## Accessibility Survey

## City of Downey Calmcrest Drive - Tweedy Lane to Cul-de-sac

Tweedy Lane to Cul-de-sac  
Downey, CA 90240

Date of Inspection  
2/8/2017

**Bush East Of Cul-de-sac @ 33.961097976157, -118.126932531595**

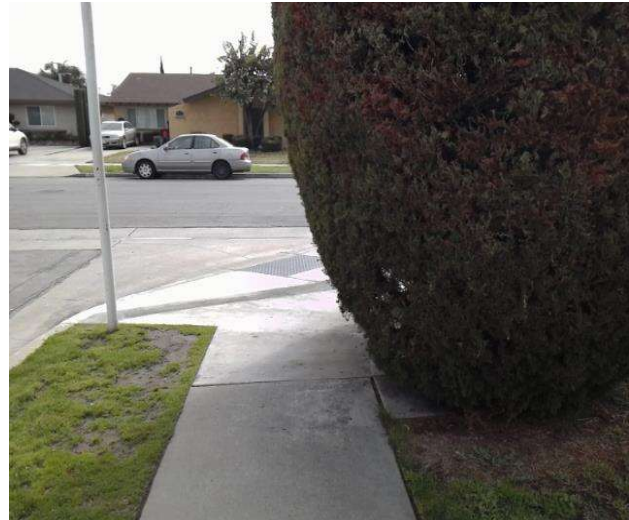
Sidewalk width at the obstruction is not compliant.

**On-Site Finding** 24.00 inches

Sidewalk width at the obstruction shall have the recommended value.

Recommendation At least 48.00 inches

**Sidewalk East Of Cul-de-sac @ 33.961570717198, -118.127621859312**

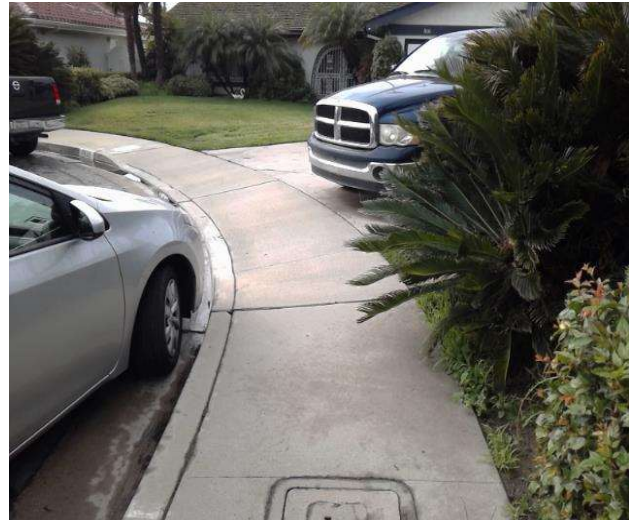
Sidewalk cross slope is not compliant.

**On-Site Finding** 4.20 percent for 100.00 feet

Repave the sidewalk surface with the recommended cross slope.

Recommendation Up to 2.08 percent
